Documentation Description: Nonconformance Report - C-03736

NONCONFORMANCE REPORT

16 NCR NO. C-03736 SU  
17 DATE ISSUED 5-12-84 18 REV 0  
19 PAGE 1 OF 6

(Door #23, WATER TIGHT) WELDS

## ATTACHMENT #1

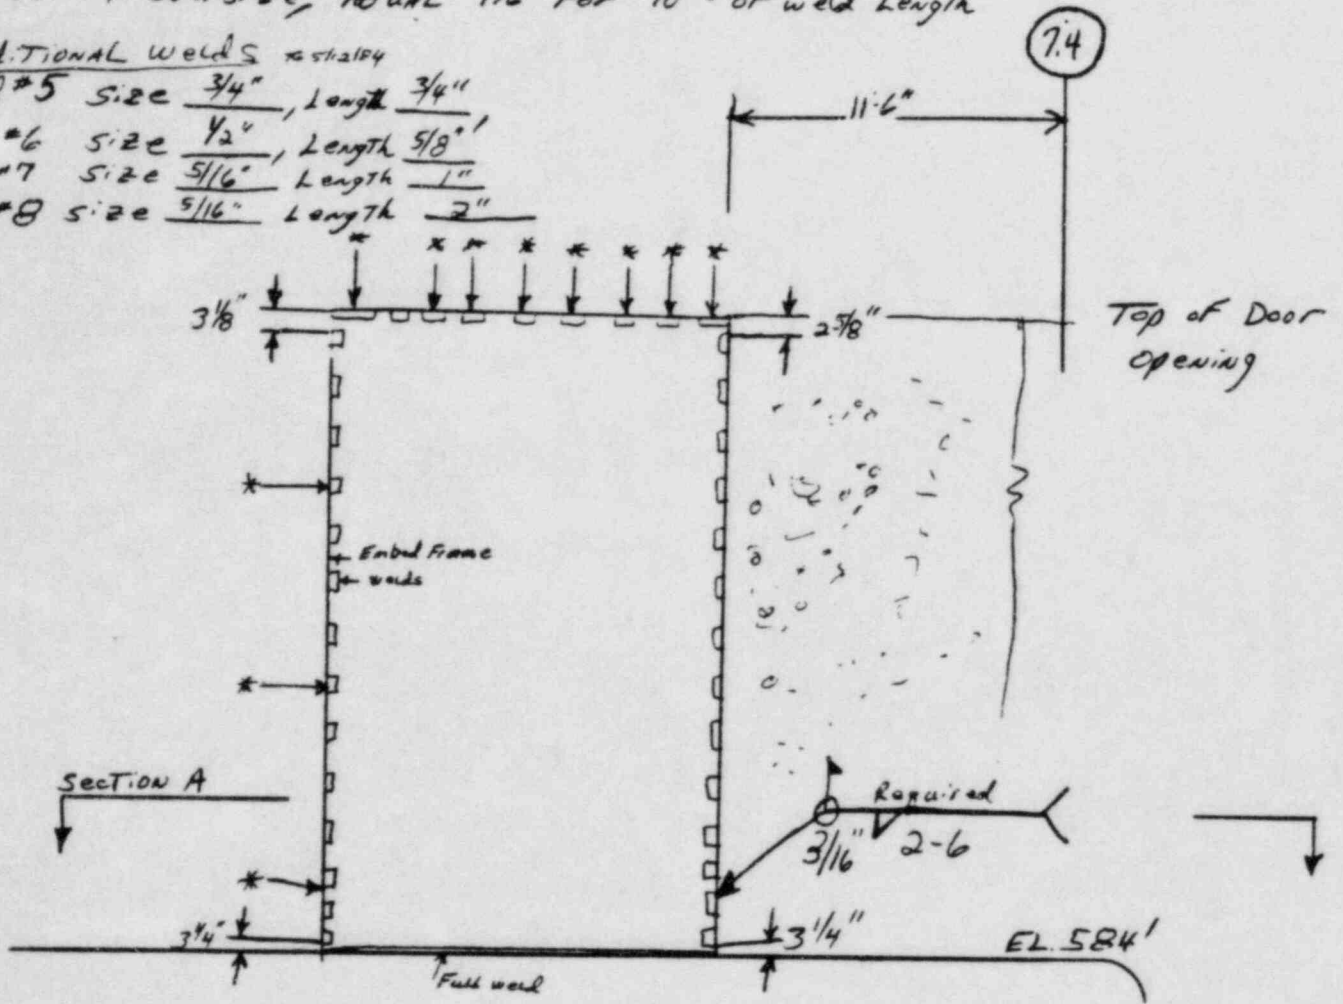
(4) THE INTERMITTENT FILLET WELDS ( $3/16"$  - 2" LONG + 6" PITCH) CONNECTING DOOR FRAME TO EMBEDDED ANGLE DOES NOT HAVE INCREMENTS AT THE ENDS. SEE ATTACHMENT #1. THIS <sup>APPLIES</sup> ~~APPLIES~~ TO THE VERTICAL ENDS OF THE FRAME ONLY.

(5) THE WELDS IDENTIFIED WITH A \* SYMBOL ON ATTACHMENT 1 ARE THOSE WITH WELD SIZES IN EXCESS OF  $+3/16"$ . THE AVG. ACTUAL SIZE IS  $7/16"$  FOR ENTIRE WELD. WELDS #3 OVERSIZE AND #4. (SEE ATTACH 1)

(6) ADDITIONAL WELDS INDICATED ON ATTACHED SKETCH SECTION <sup>"ARE</sup> ~~"ARE NOT~~ SHOWN ON DRAWINGS.

NOTE  $1/4"$  GRIND OFF OF WELD #7 (LENGTH), THESE WELDS <sup>CONNECT</sup> ~~"ARE NOT~~ WALL EMBEDDED ANGLE FRAME TO EMBEDDED FLOOR ANGLE FRAME.

- ① The symbol \* indicates (oversize welds, #1) to shaly
- ② Weld #3 oversize, ACTUAL  $7/16"$  For 10% of weld Length  
Weld #4 oversize, ACTUAL  $7/16"$  For 10% of weld Length

- ③ Weld #5 size  $3/4"$ , Length  $3/4"$
- Weld #6 size  $1/2"$ , Length  $5/8"$
- Weld #7 size  $5/16"$ , Length  $1"$
- Weld #8 size  $5/16"$ , Length  $2"$
